**DEL WEBB AT MIREHAVEN PHASE 3 & 4  
 (TRACT M AND TRACT N-2-A-1, WATERSHED)**

Re: Del Webb at Mirehaven Phase 3&4 Grading and Drainage Plan and Drainage Report  
Engineers Stamp Dated: 05/10/2018 (H09D017G)

Enclosed are responses to the comments provided on June 19, 2018. Responses are listed in red below.

**DEL WEBB @ MIREHAVEN PHASE 3**  
WALL DRAINAGE STRUCTURE DETAIL

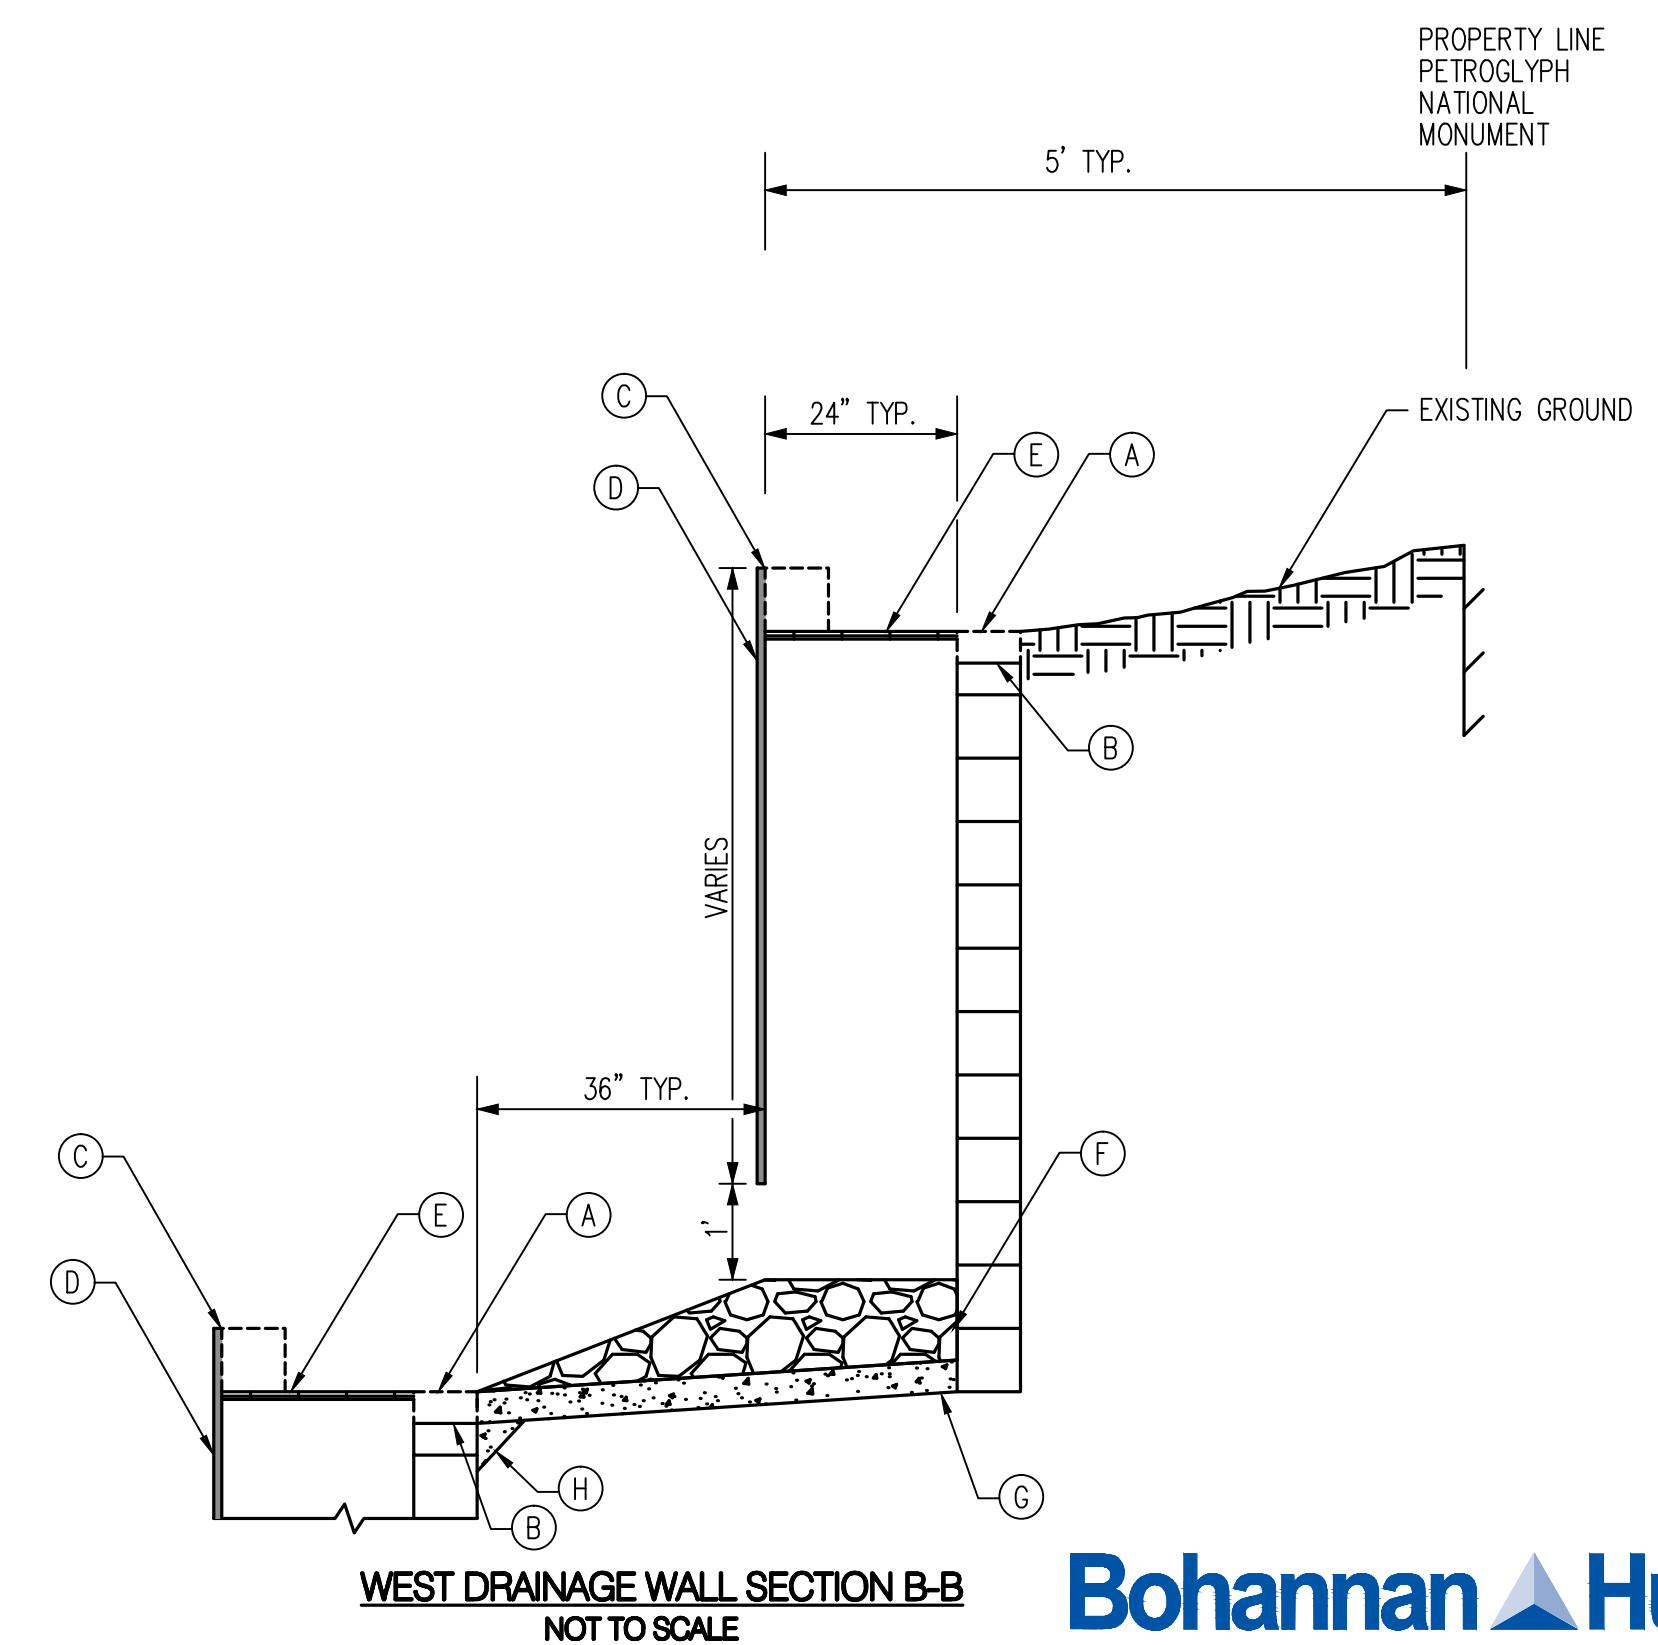
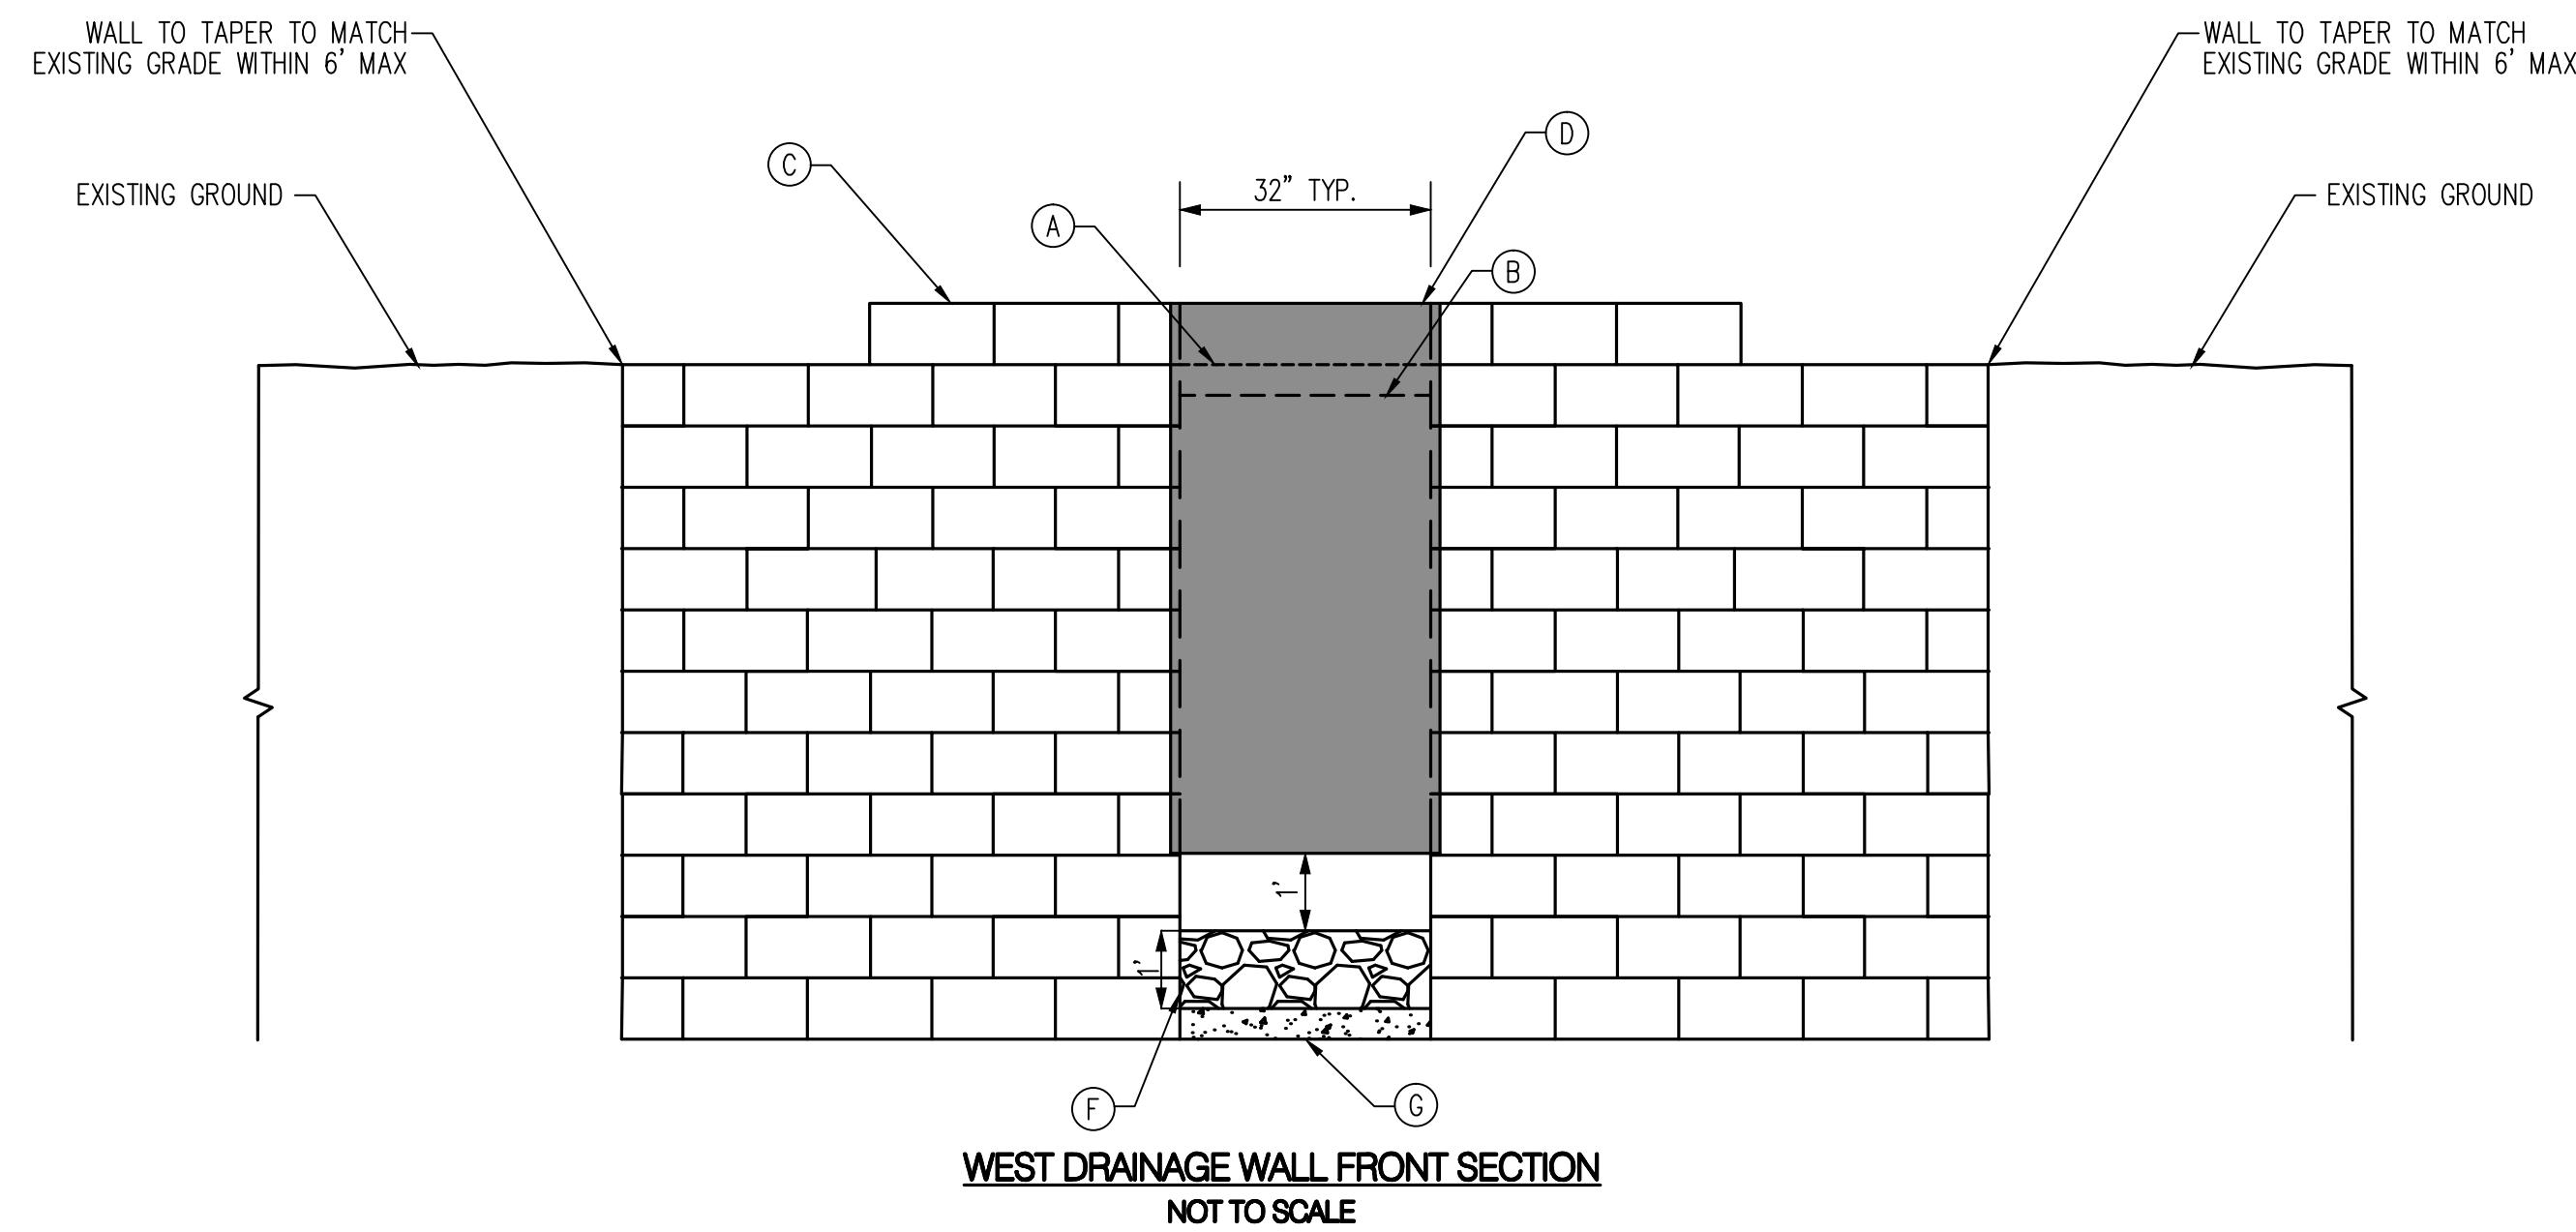
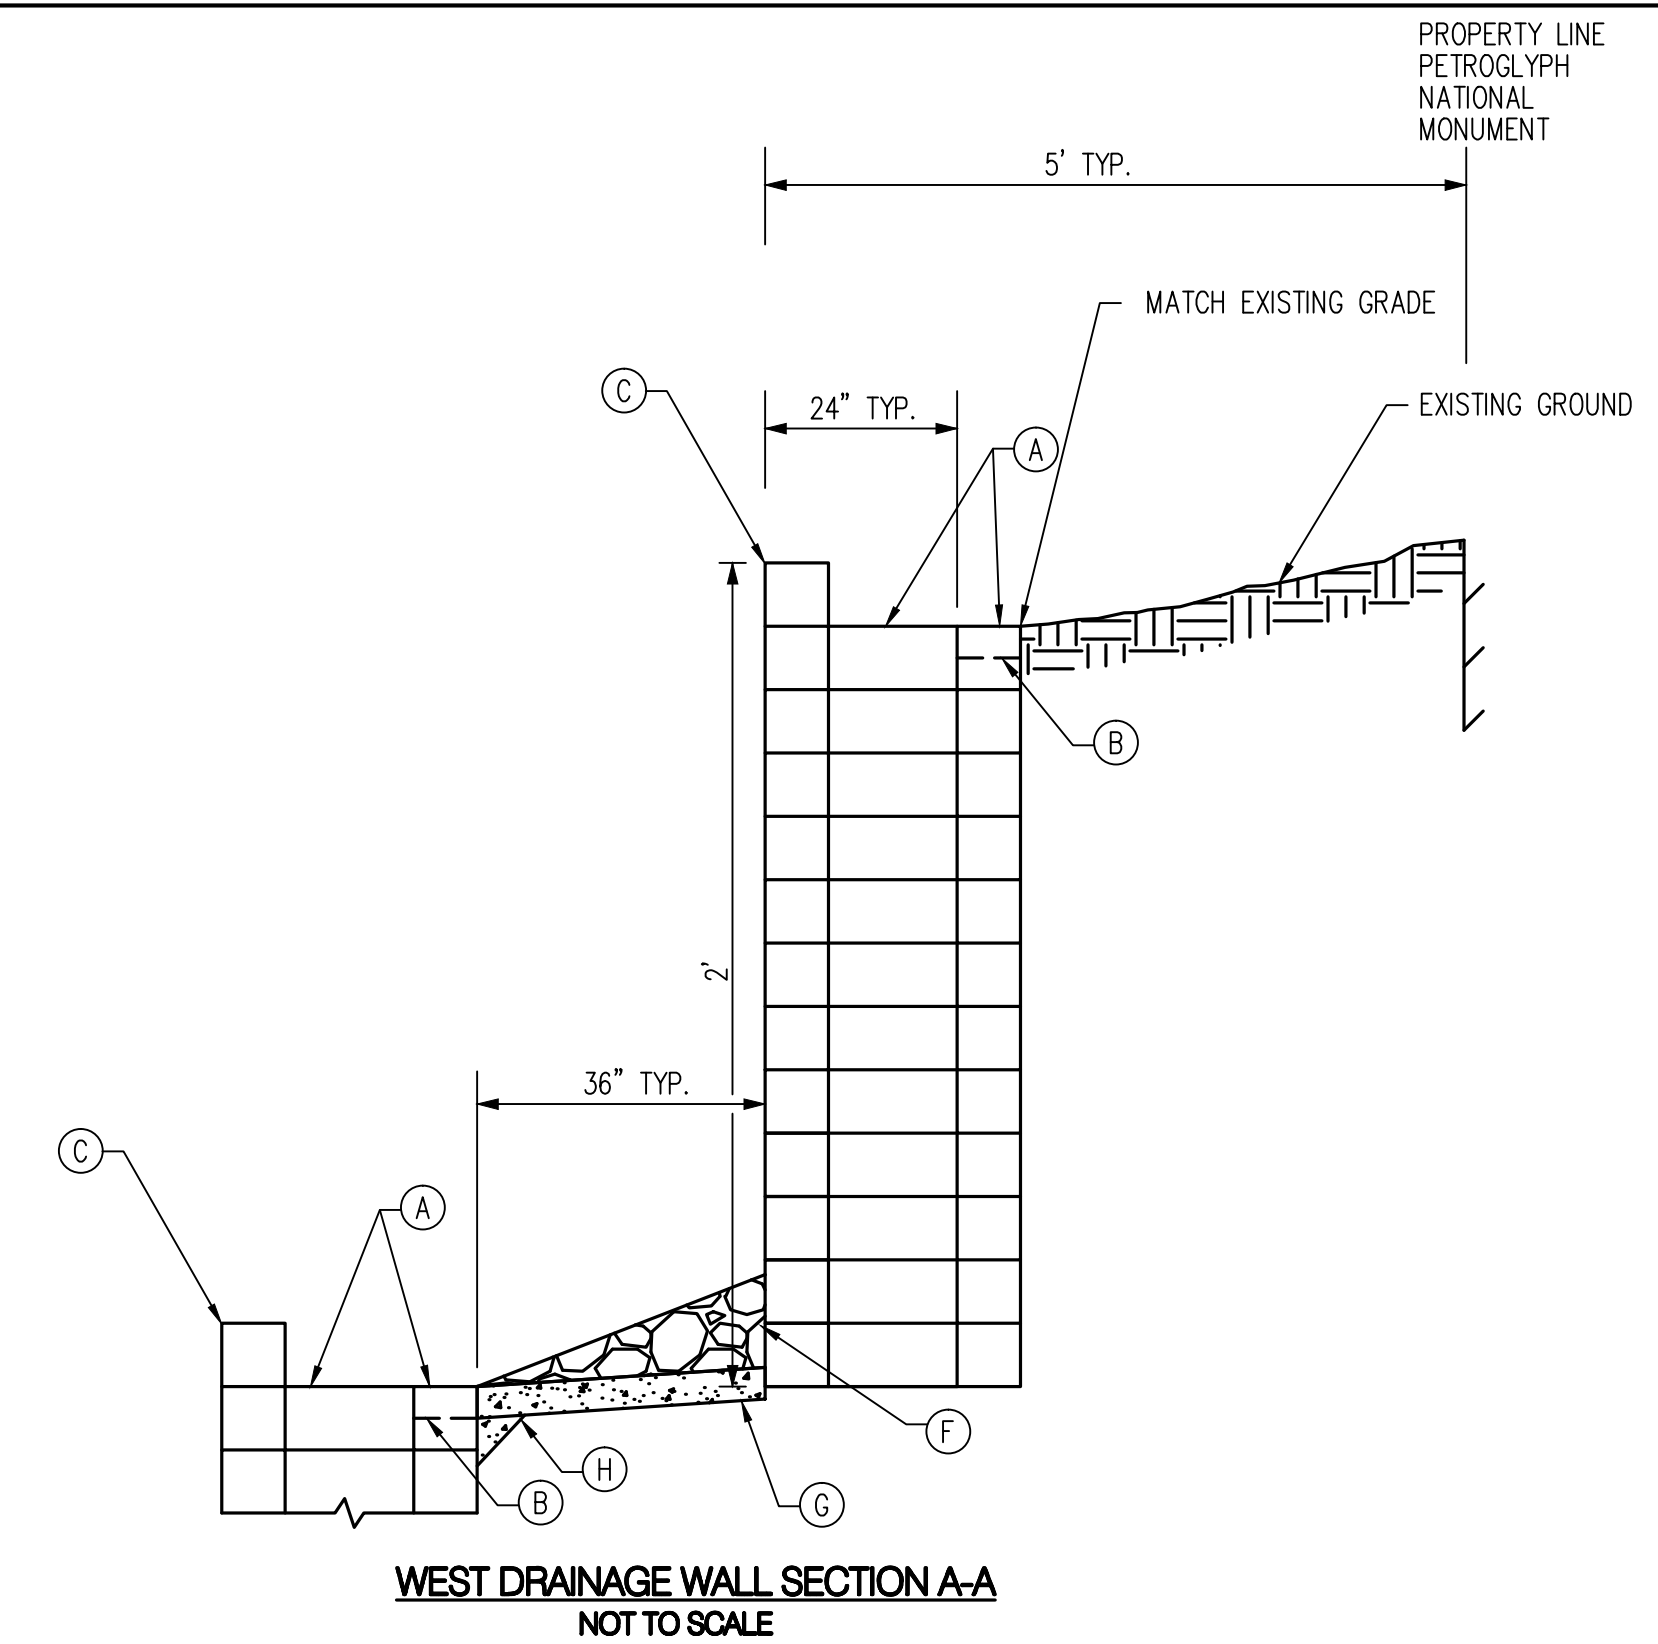
3. Change "North" to "West" on the detail sheets of concentrated flow paths down the steep slopes next to the National Monument. **This has been corrected.** Modify the detail to prevent runoff from flanking the drainage structure. **No modification necessary. A weir calculation is provided to show that the current design can handle of the offsite flow getting to each structure.** Show the property line on the detail. **This has been added** Also add a note to the contractor instructing him; "No disturbance is allowed on the monument, if damage occurs to neighbor's property then written acceptance of the repairs will be required prior to acceptance of Engineer's Certification. Contractor must

immediately stabilize the slope to prevent erosion from encroaching into the neighbor's property per details on sheet 4 of Unit 4 and sheet 6 of Unit 3".

Note has been added.
